ADDENDUM NO. 1

17th & Dunn Intersection Improvements Project

Issued From: The City of Bloomington
Engineering Department
Post Office Box 100
401 North Morton Street, Suite #130
Bloomington, Indiana 47404

Issue Date: March 9, 2021

Pedestrian Maintenance of Traffic

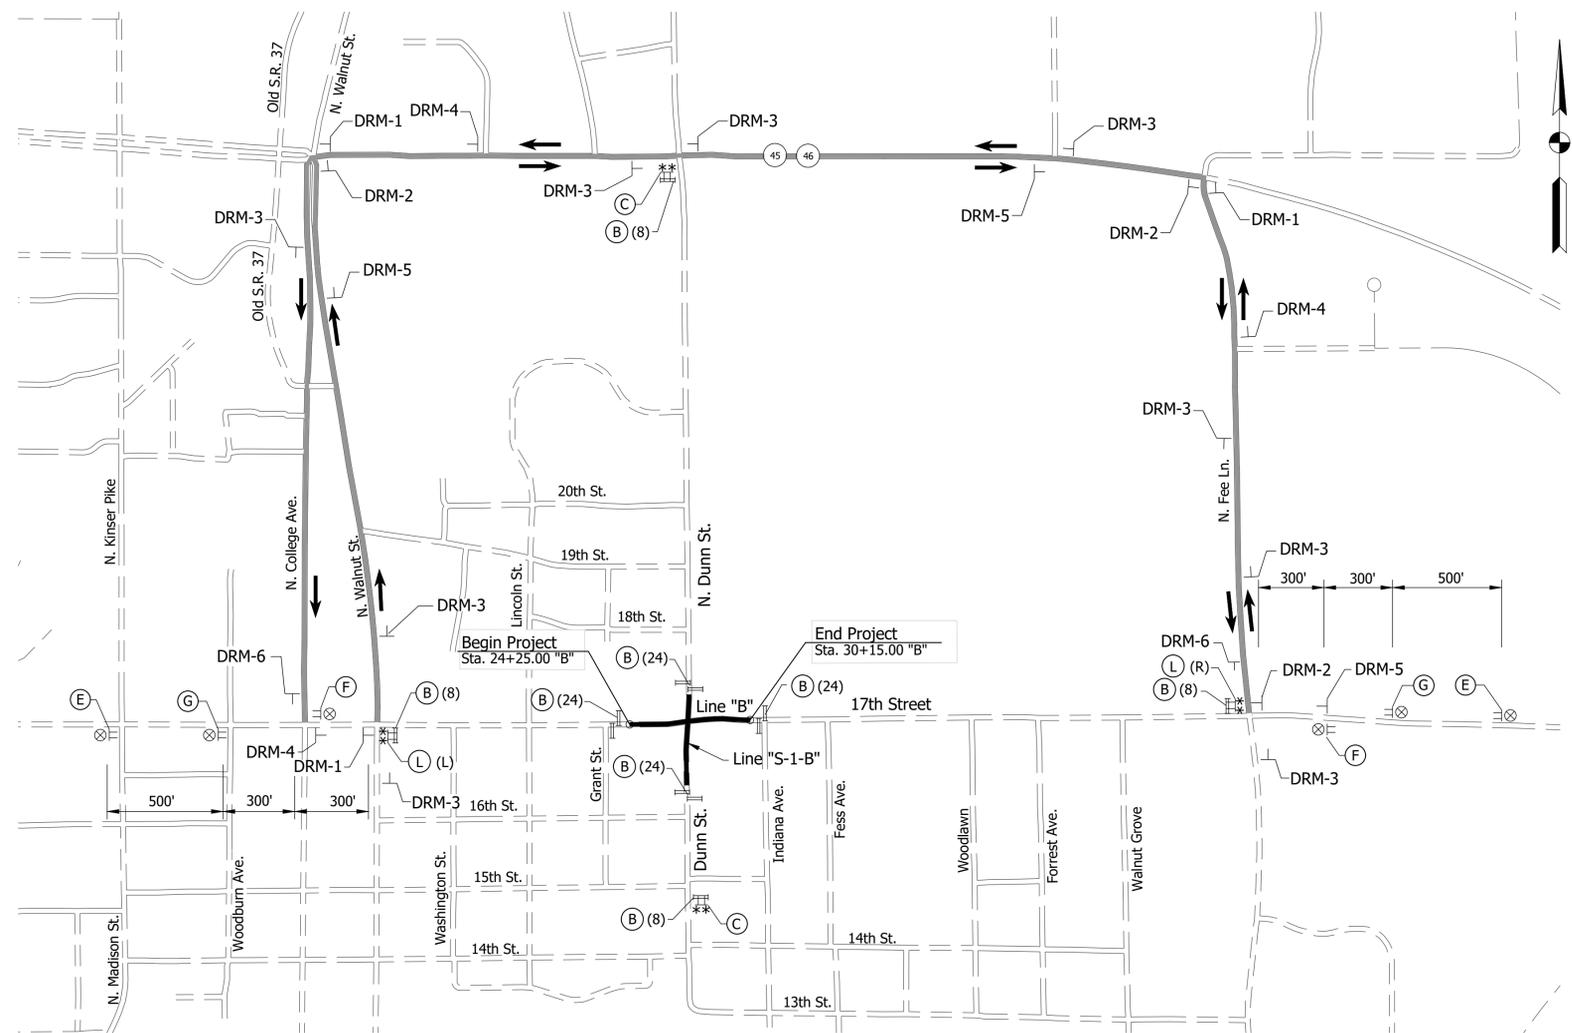
Item No. 2: The Maintaining Pedestrian Accessibility during Construction section of the Special Provisions has been updated. The updated sheet is attached to the Addendum. The Maintenance of Traffic detour page, Sheet 7, of the Plan Set, has been updated and the updated sheet is included in the Addendum. The quantity for Pay Item 85, Construction Sign, B, has been changed to 26 (Each). The quantity for Pay Item 87, Barricade, III-B, has been changed to 176.00 LFT. The Unit Price Sheet has been updated to reflect these changes and the updated sheet has been attached to this Addendum.

Maintaining pedestrian access within the intersection is not required during the full closure of the intersection. The sidewalks shall be closed, and signs placed per the plans.

Sidewalk closure outside of the full intersection closure is not allowed without approval by the Engineer. If the Contractor completes work outside of the full closure time period that requires sidewalk closure then the Contractor shall provide temporary accommodations for pedestrians. The cost of the temporary accommodations shall not be paid for directly, but rather included in the cost of other items. The Engineer shall approve the final layout of the temporary pedestrian accessibility at each location prior to closing the existing sidewalk.
